Service Bulletin

No.: MZ09-100

Model: SR6004, SR5004

Subject: A Hum Noise occurs at shorting of FRONT AUX Audio input.

Bottom SIDE of CUP12205Z/Y AUX P.W.B. (FRONT P.W.B. ASSY)

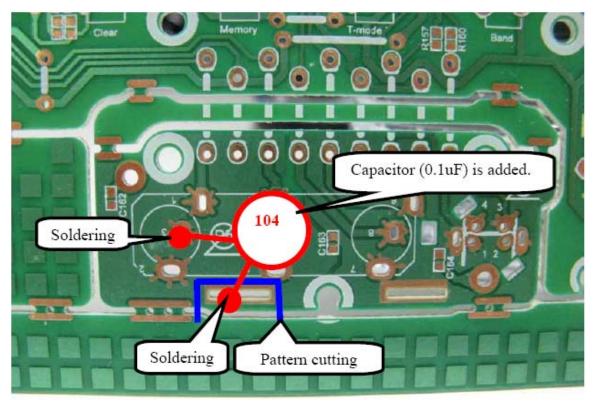
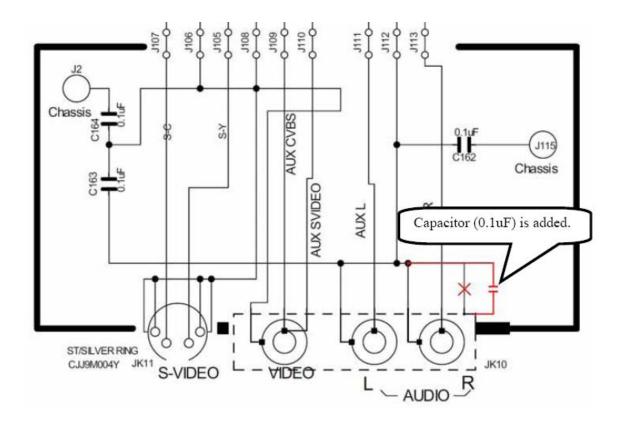
Symptom: The AUX Audio input (Front) terminal is shorted at MAIN Volume MAX. The Hum noise is louder than REAR AUX input terminal in the rear panel. The earth side of the AUX input terminal is connected directly with the chassis, the earth circuit is looped.

Solution: Add a capacitor and cut the trace as outlined.

Please add the following capacitor on AUX P.W.B. (FRONT P.W.B. ASSY: CUP12205Z/Y) and cut the pattern as shown below.

Ref. Nr.	Parts Number	Parts Name	Remarks
1	nsp		0.1uF+80/-20% /50V CERAMIC Capacitor CCBS1H104ZFT
